# ADDENDUM

NO. 1

**PROJECT NAME:** Fielder Road Modular Site

## ARCHITECTURAL ITEMS FOR ADDENDUM NO. 1

SHEET NUMBER  
C-06

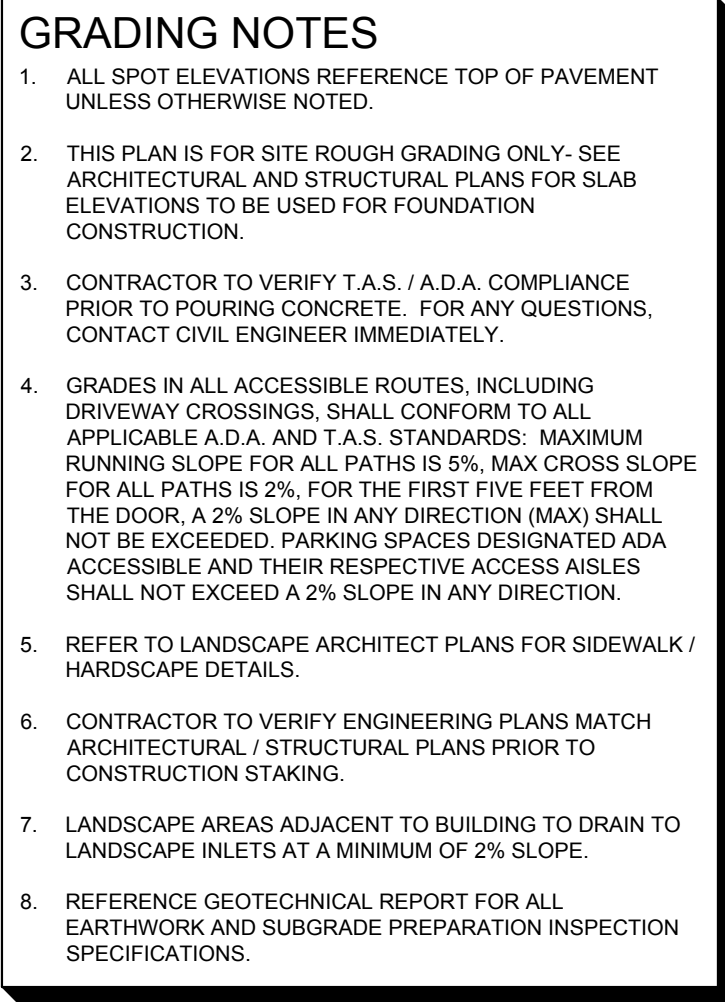
**AD No 1, Civil Item 3: To the Drawings, Sheet C-06, "Grading Plan,"**

- 1) Added a small retaining wall to the East side of the building.

C-10

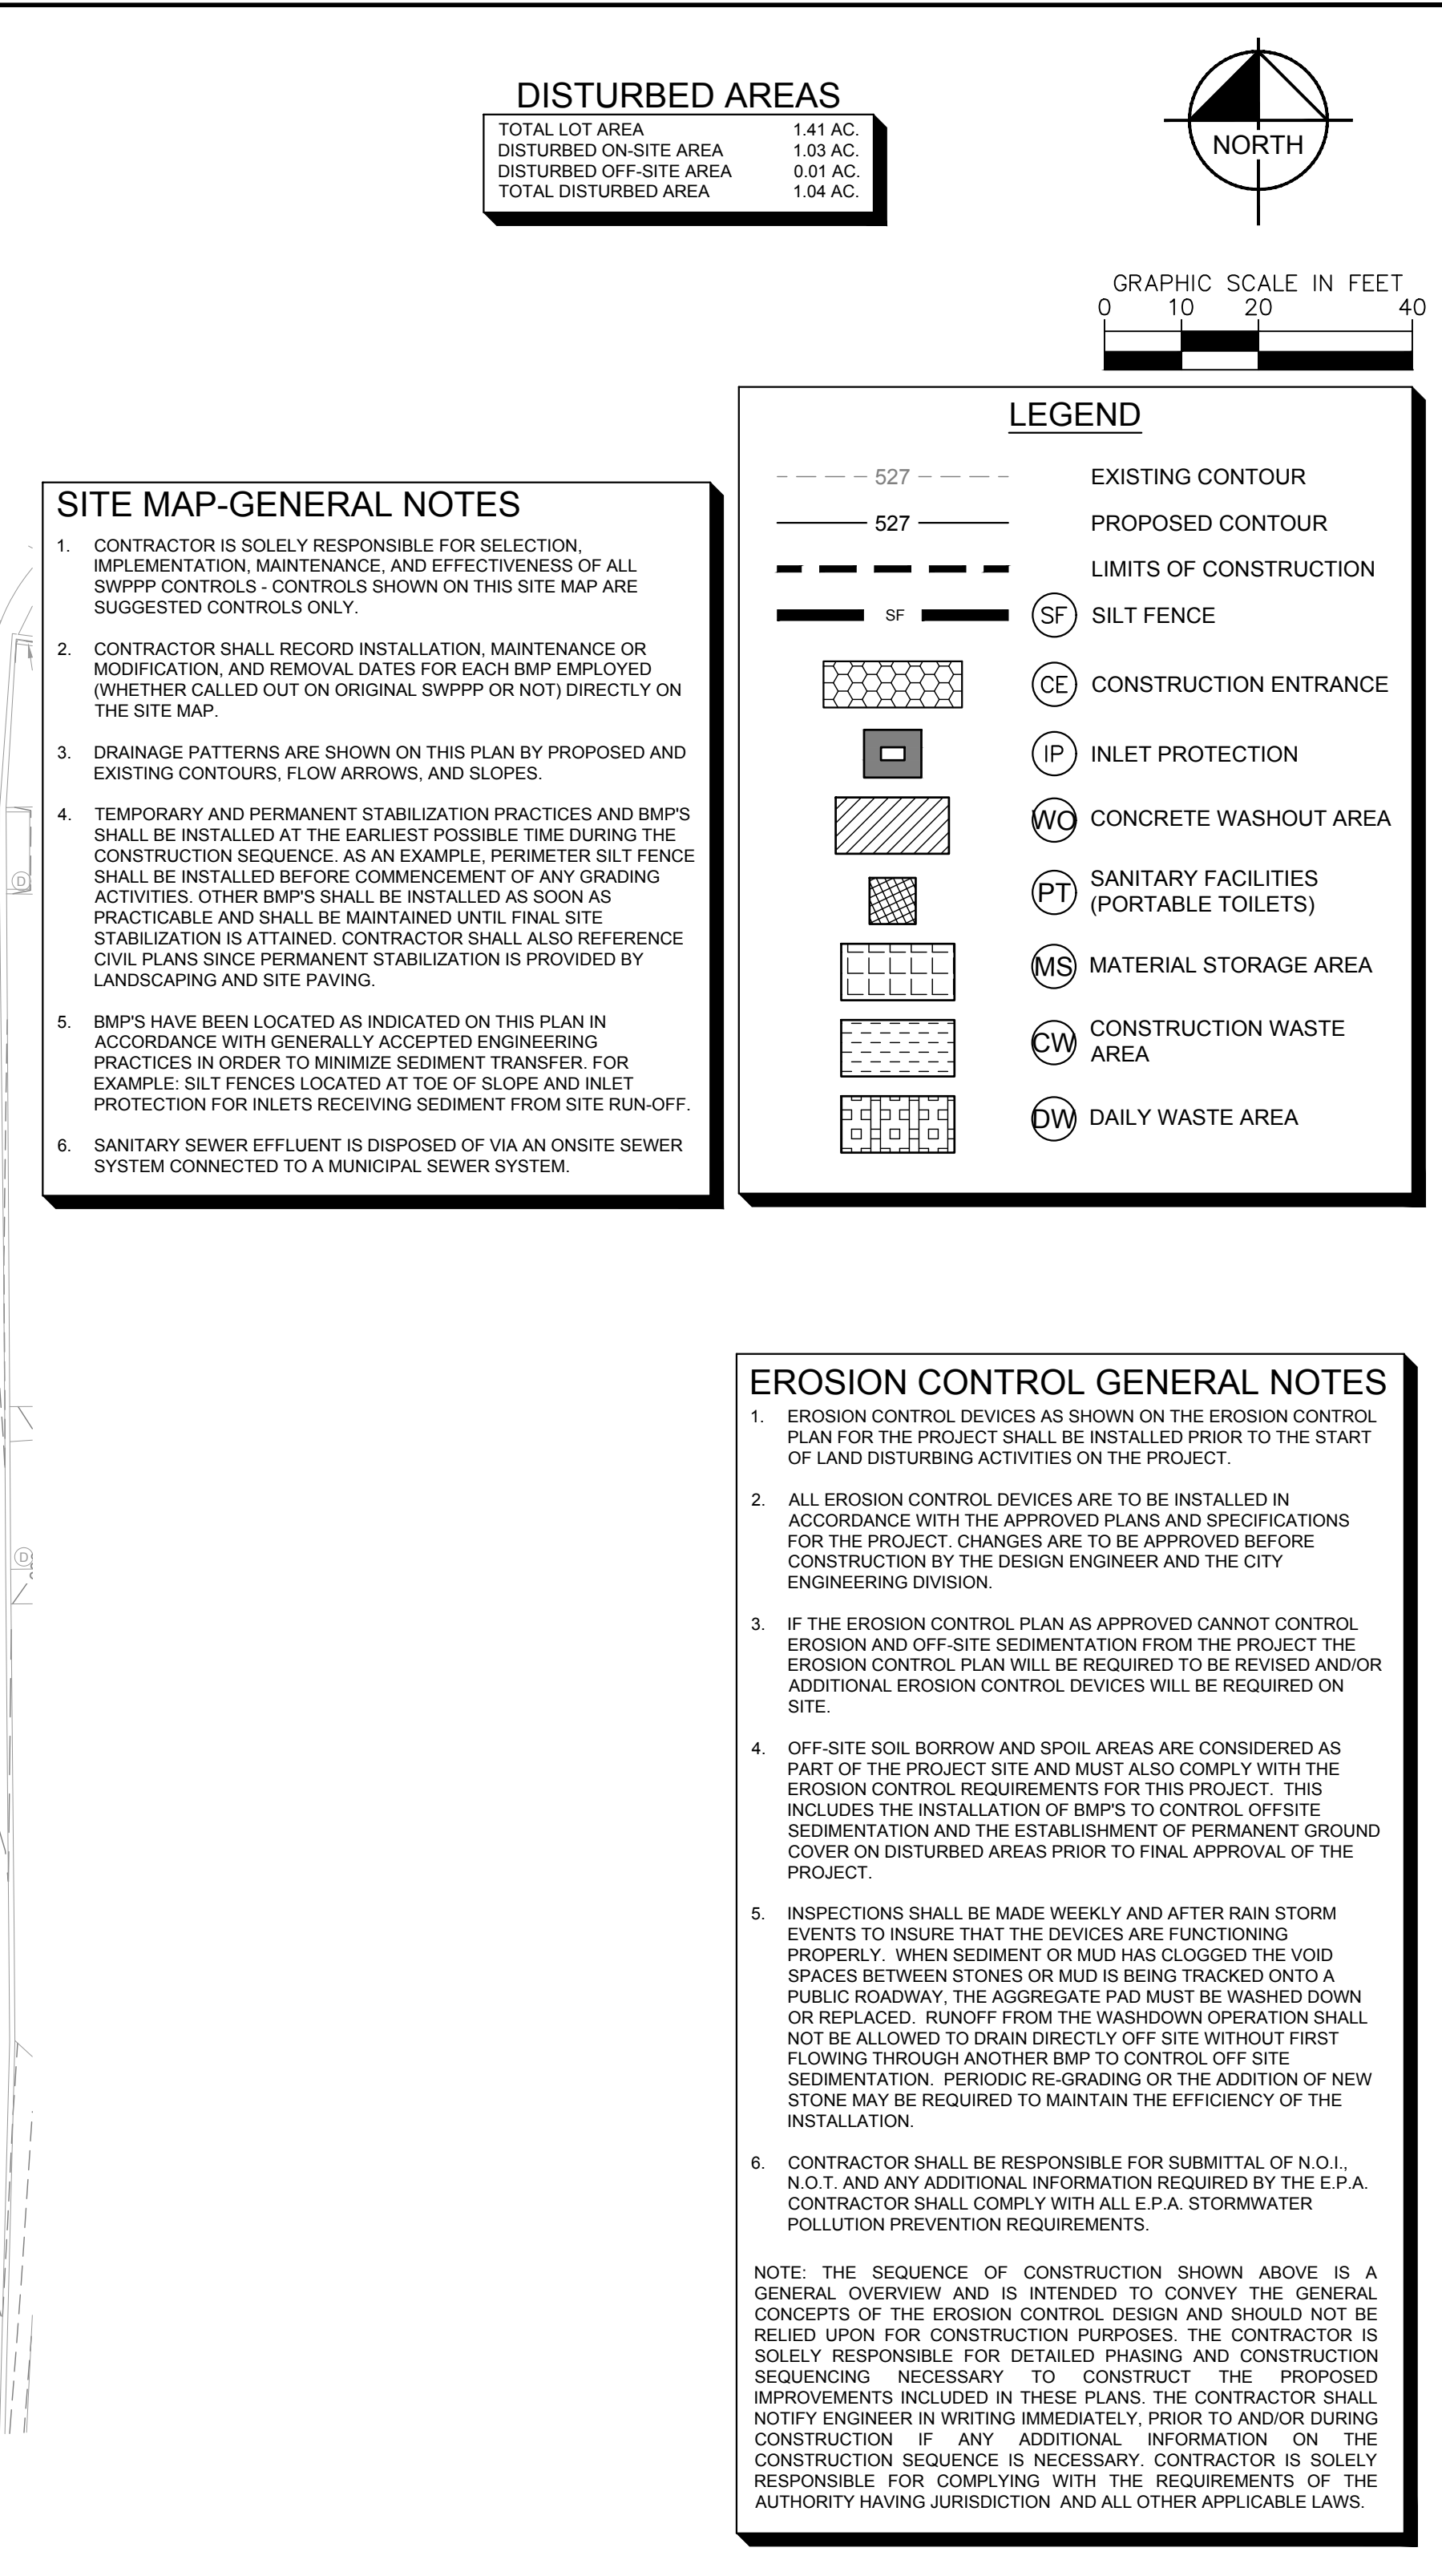
**AD No 1, Civil Item 4: To the Drawings, Sheet C-10, "Utility Plan,"**

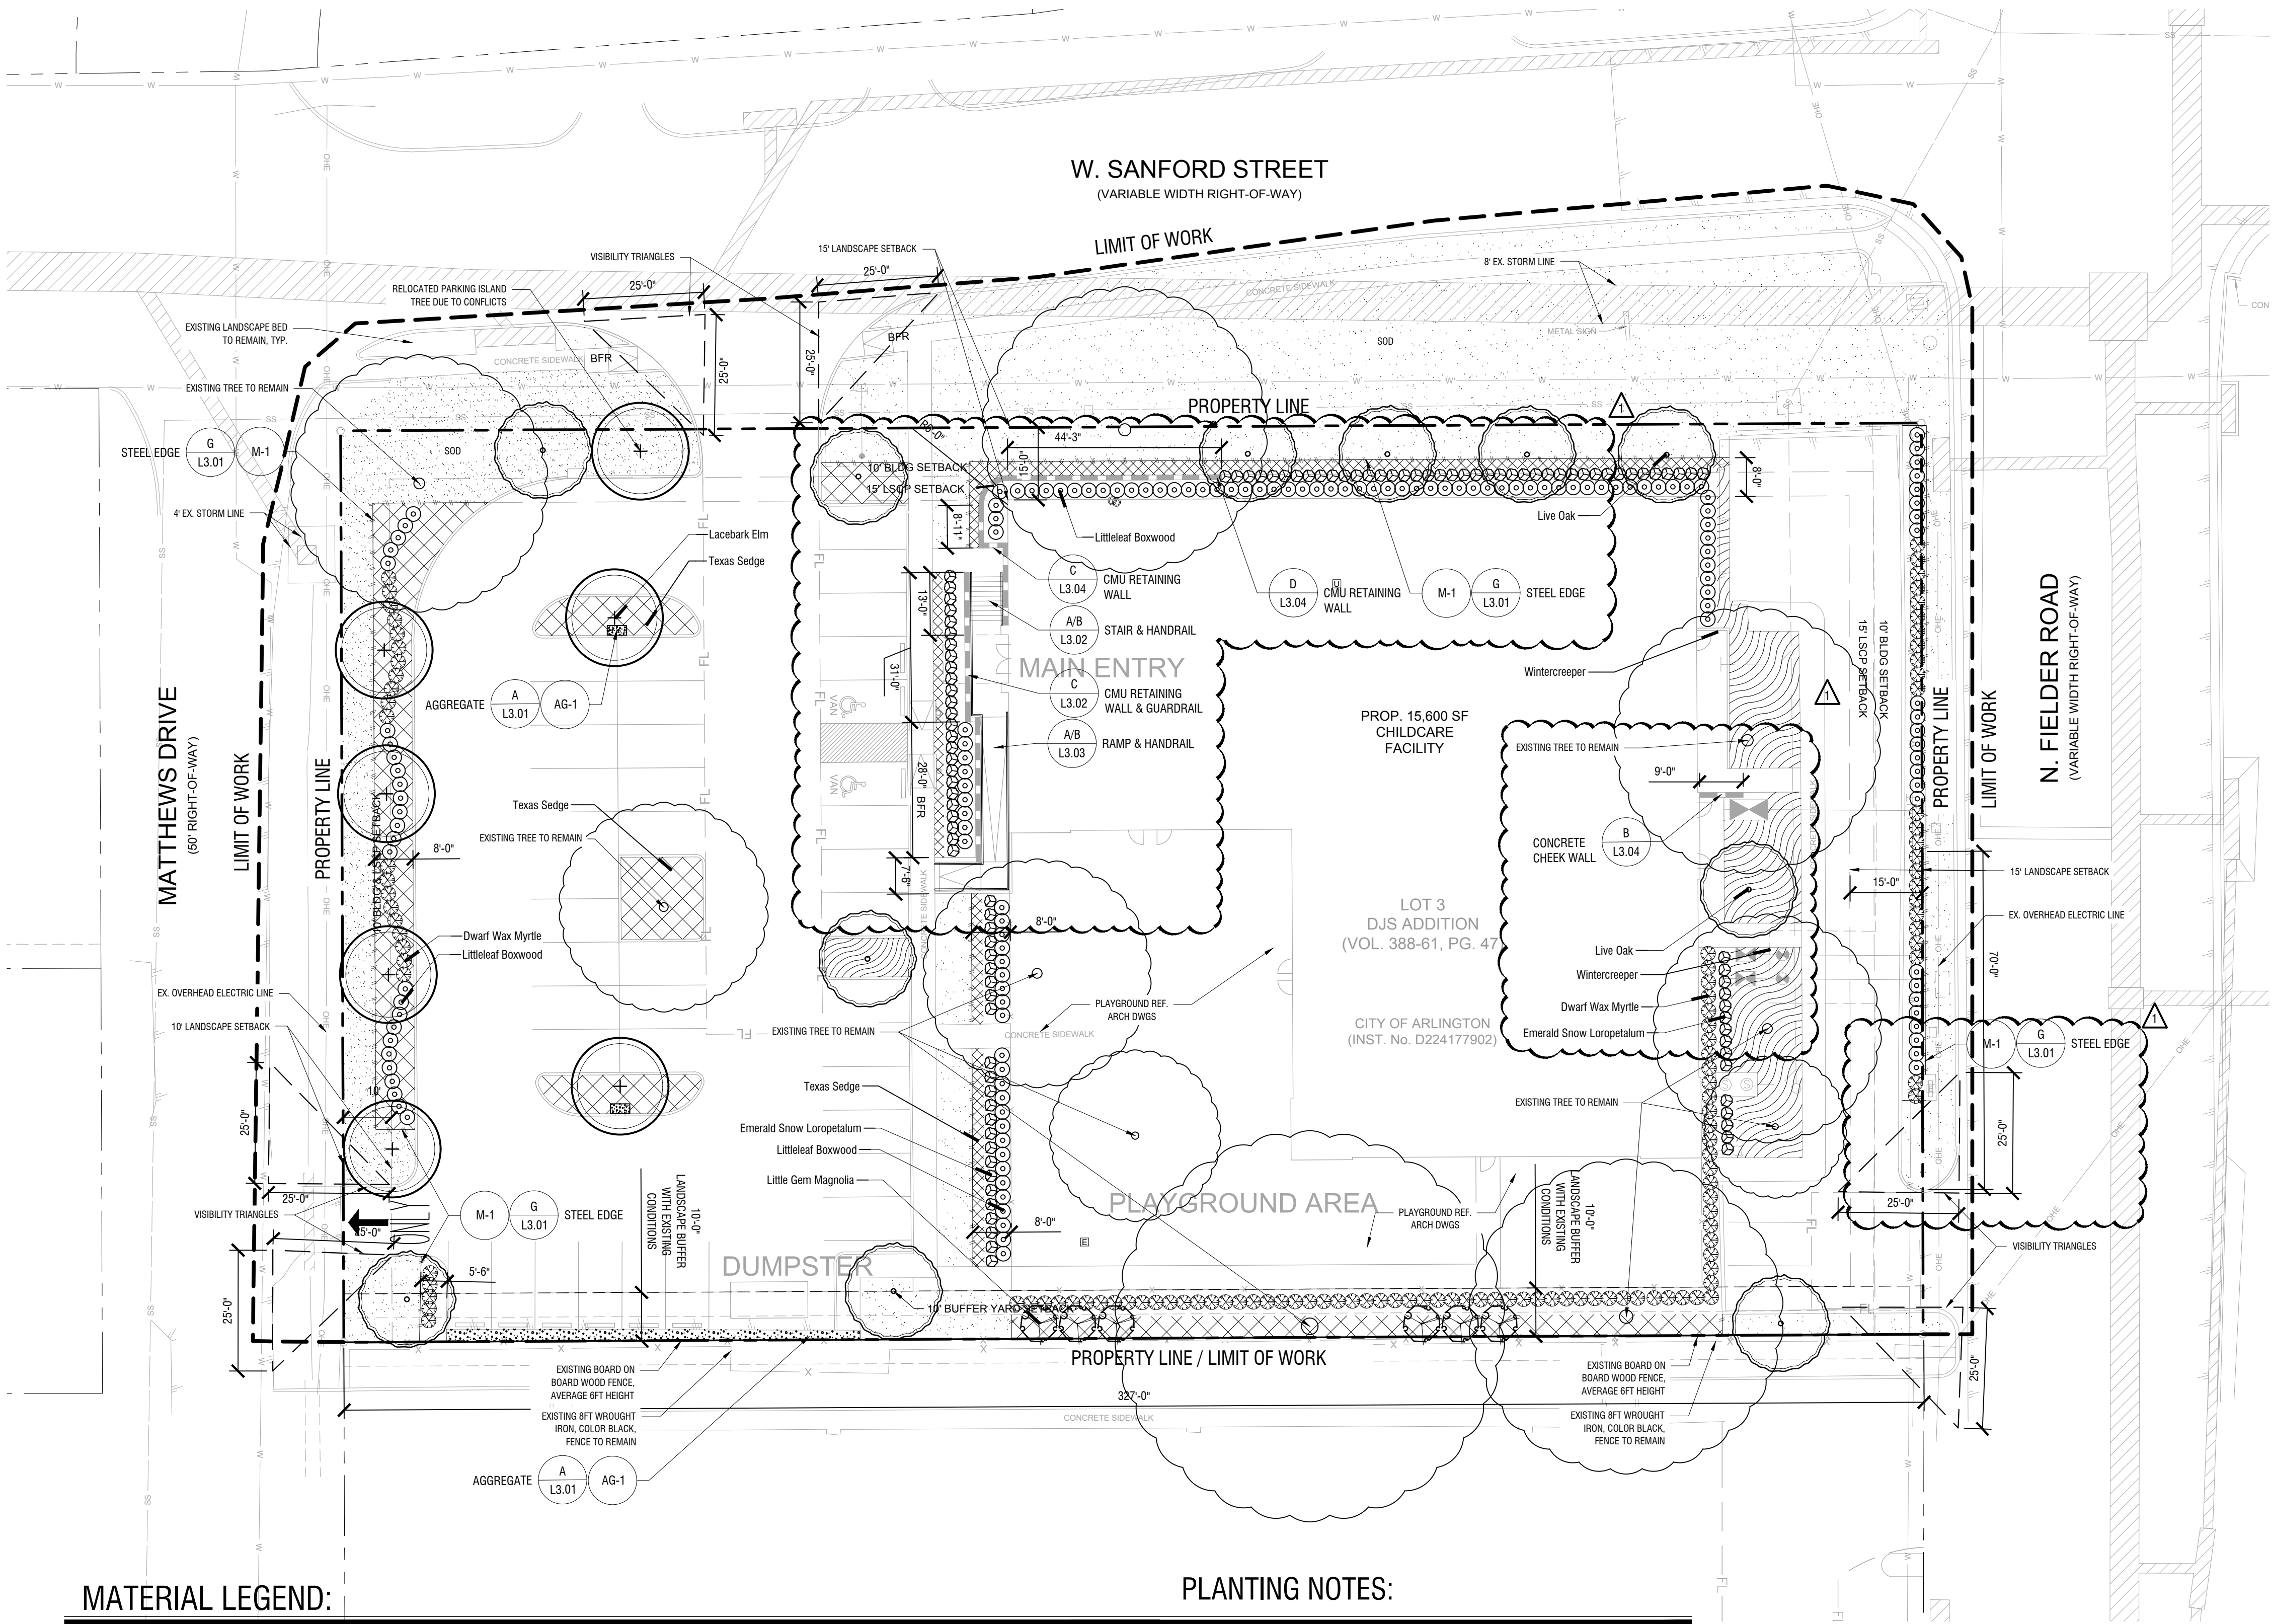
#### AD No 1, Landscape Item 2: To the Drawings, Sheet L2.01

- 1) Updated the landscape plans to callout retaining wall, ramp, stair and handrail/guardrail location.
- 2) Updated the landscape at visibility triangle per city comment.
- 3) Updated the landscape at the revised sidewalks along the building façade facing N. Fielder Road.
